## MINERALS PROGRAM INSPECTION REPORT

<b>MINE NAME:</b> Midwestern Farms	<b>MINE/PROSPECTING ID#:</b> M-1993-059	<b>MINERAL:</b> Sand and gravel	<b>COUNTY:</b> Prowers
<b>INSPECTION TYPE:</b> Monitoring	<b>INSPECTOR(S):</b> Amy Eschberger	<b>INSP. DATE:</b> November 22, 2016	<b>INSP. TIME:</b> 13:00
<b>OPERATOR:</b> Midwestern Farms	<b>OPERATOR REPRESENTATIVE:</b> Mel DePra	<b>TYPE OF OPERATION:</b> 112c - Construction Regular Operation	
<b>REASON FOR INSPECTION:</b> Normal I&E Program	<b>BOND CALCULATION TYPE:</b> Complete Bond	<b>BOND AMOUNT:</b> \$1,583,000.00	
<b>DATE OF COMPLAINT:</b> NA	<b>POST INSP. CONTACTS:</b> None	<b>JOINT INSP. AGENCY:</b> None	
<b>WEATHER:</b> Cold, windy, light rain	<b>INSPECTOR'S SIGNATURE:</b> 	<b>SIGNATURE DATE:</b> December 28, 2016

# M1993-059 / Midwestern Farms / Midwestern Farms

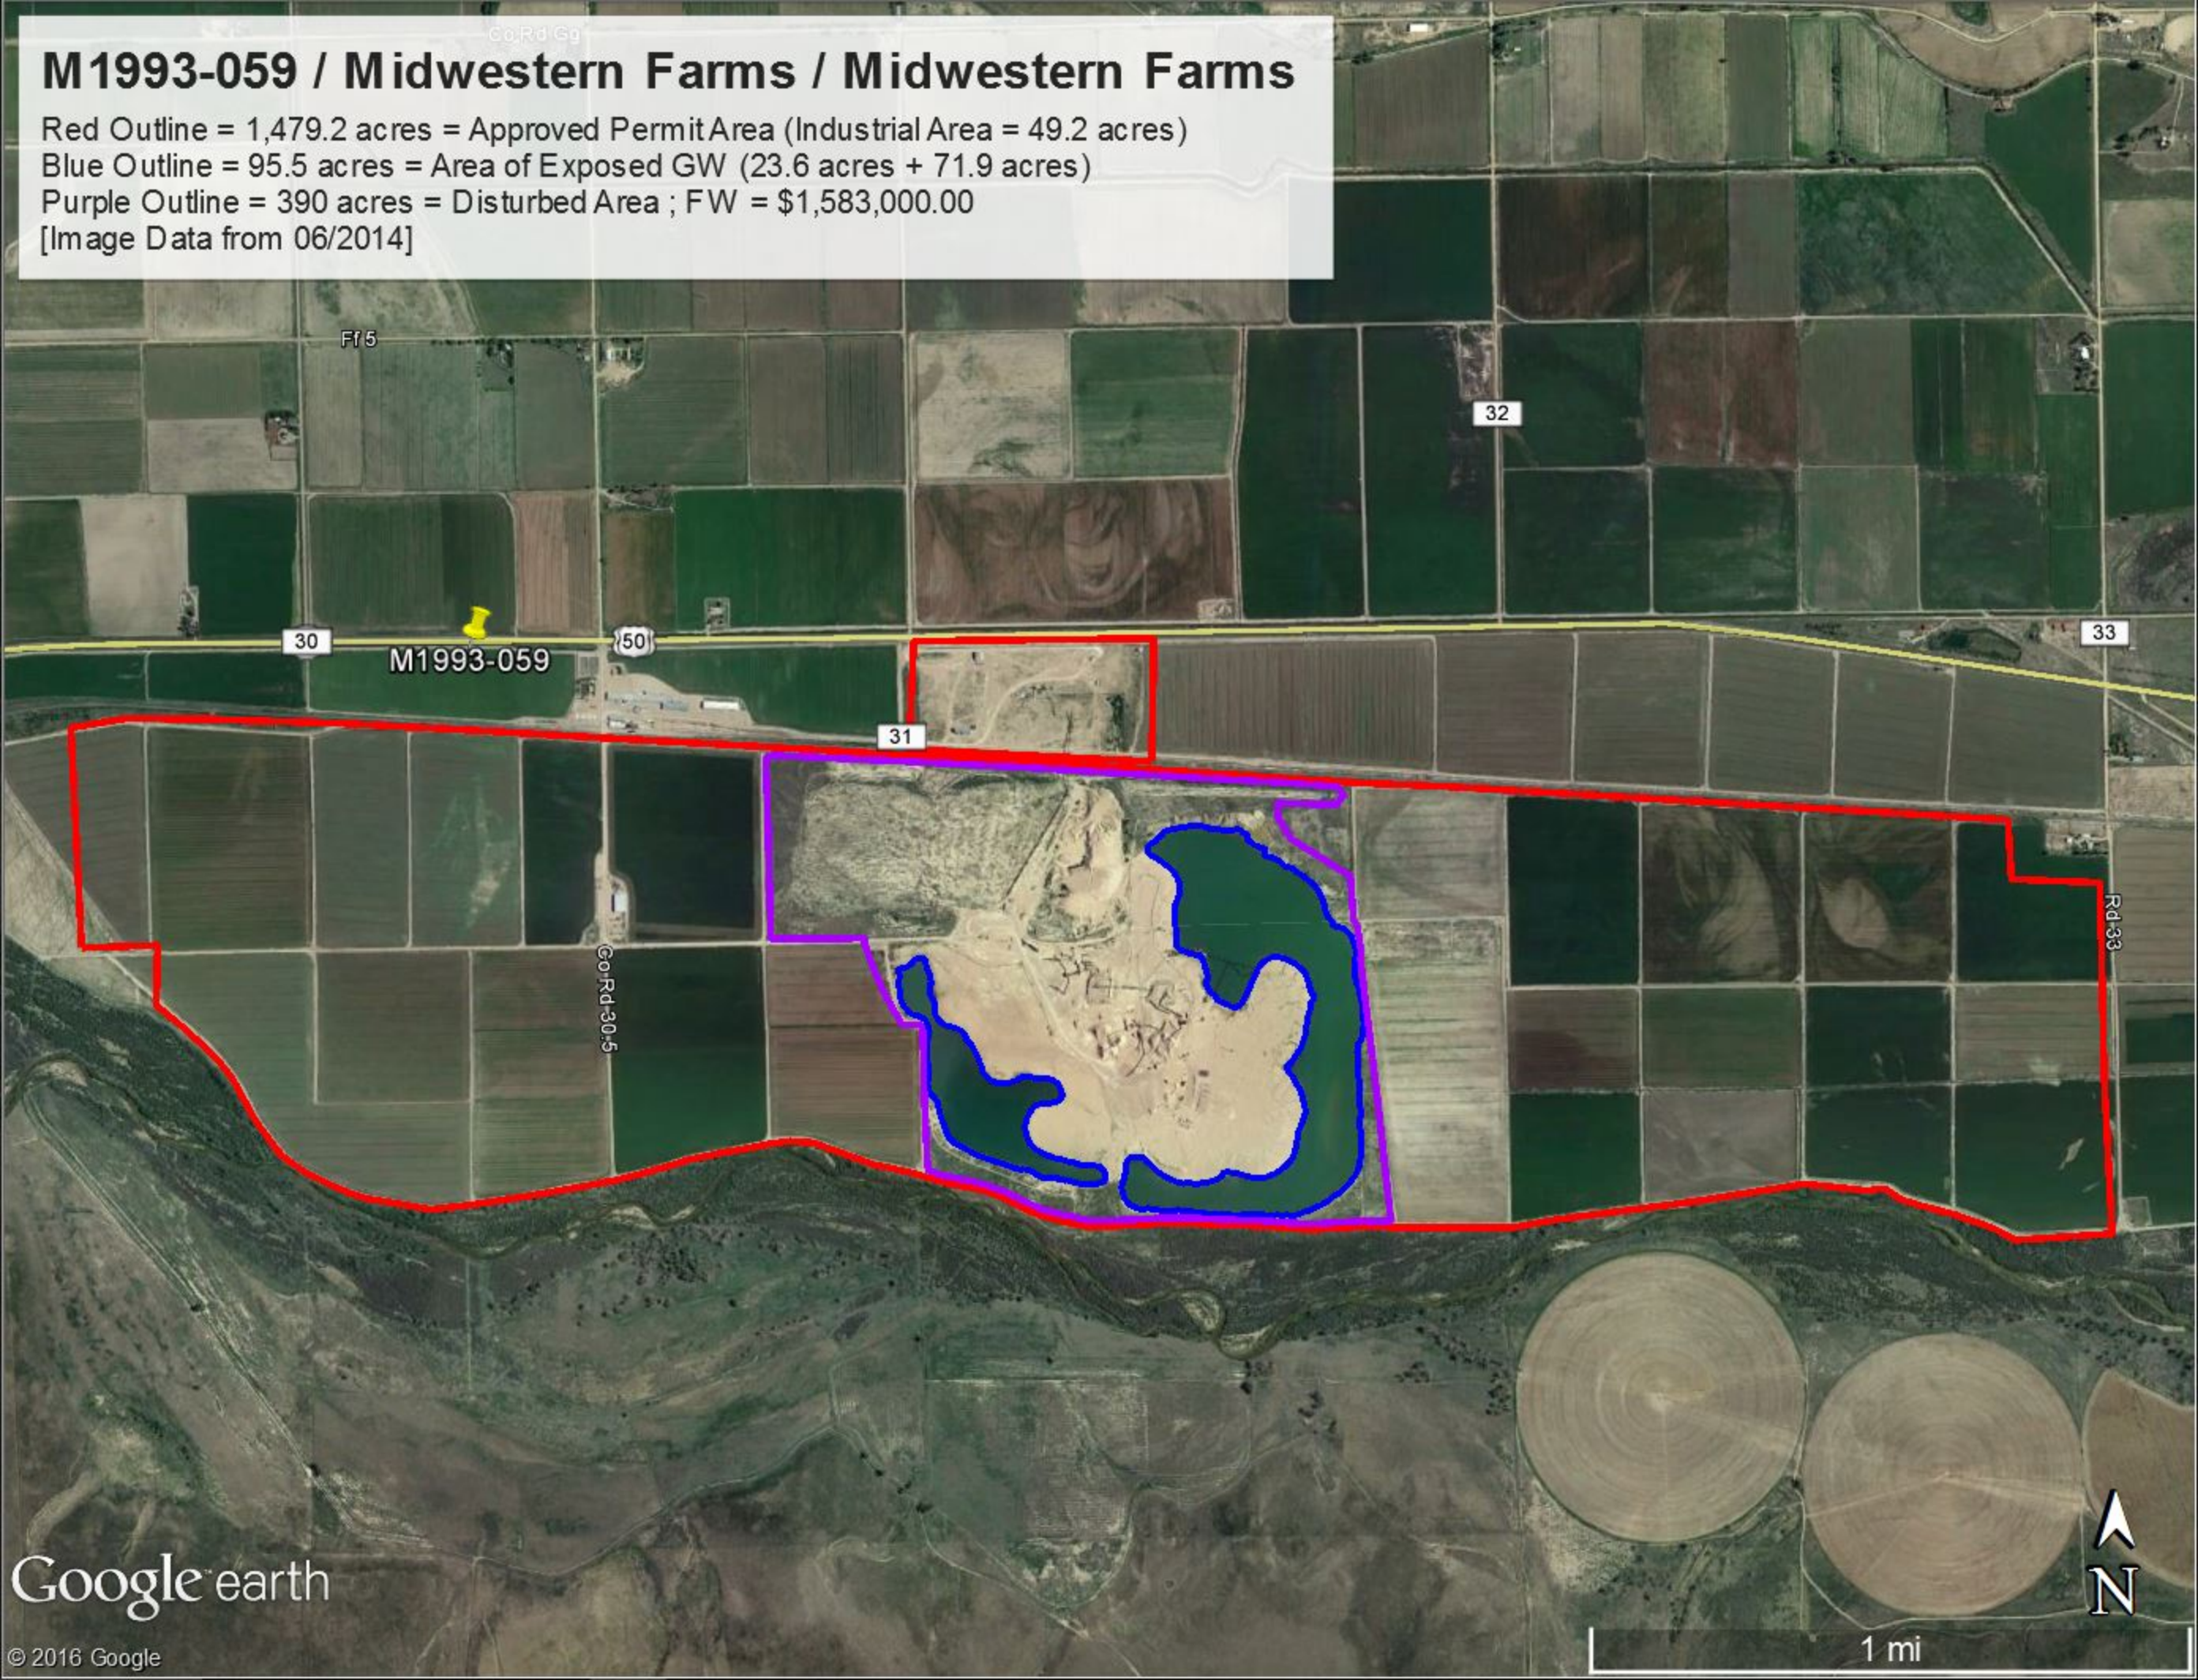
This is a 112c operation permitted for 1,479.2 acres (see enclosed Google Earth image of site) to mine sand and gravel via the floating suction dredge method to maximum depths of 60 feet. The maximum allowed disturbed acreage at any time is 390 acres, as approved in Revision No. TR-03 on March 02, 2015. A surety increase was issued in 2014 to account for 245 acres of disturbance more than what was approved at that time, and included the removal of a large sand stockpile stored on site. The approved mining plan calls for mining in six major phases, with concurrent reclamation to occur. The approved reclamation plan calls for leaving two ponds per mined phase, each approximately 10-15 acres in size, with a 40 foot wide shallow shelf area (wetlands) created along the shoreline of each pond at 6H:1V slopes. The approved post-mining land use is industrial/commercial for 49.2 acres located north of the railroad tracks, general agriculture (dryland farmland) for 64.2 acres disturbed south of the railroad tracks, wildlife habitat and recreation for the pond areas, and rangeland for the remainder of the site.

During the inspection, the Division first observed the western pond, which is approximately 23.6 acres in surface area (**see enclosed Google Earth image of disturbed area**). This pond has been designated as a state wildlife area by CPW, where public fishing is allowed. The shoreline of this pond has slope gradients of mainly 3H:1V or flatter (**Photos 2-5**). The slope gradients below water line are undetermined. The Division was unable to observe slopes below water line during the inspection due to wave action in the ponds. The western and southern shorelines are well vegetated with native grasses, forbs, and some annual weeds (e.g., Russian thistle, wild sunflowers), and appeared to be stable (**Photos 6 and 7**). The eastern shoreline is flatter and remains sandy with no vegetative cover. Although the map that was submitted with TR-05 is difficult to read, it appears the operator is proposing to leave a portion of the eastern shoreline sandy for use by migratory birds (per CPW's recommendation).

It should be noted that the revised reclamation plan map submitted with TR-05 appears to show the 49.2 acre industrial/commercial area located above the railroad tracks to have been "previously released from mining permit". Please be advised the Division has no record of an acreage reduction approval for this portion of the permit area. Therefore, this area is still considered to be part of the total approved permit area of 1,479.2 acres. The Division believes this area meets the post-mining land use of industrial/commercial, and could be released upon submittal of an acreage reduction request. However, until it is released, the operator should ensure that any maps submitted to the Division include the industrial/commercial area located above the railroad tracks in the permit boundary.
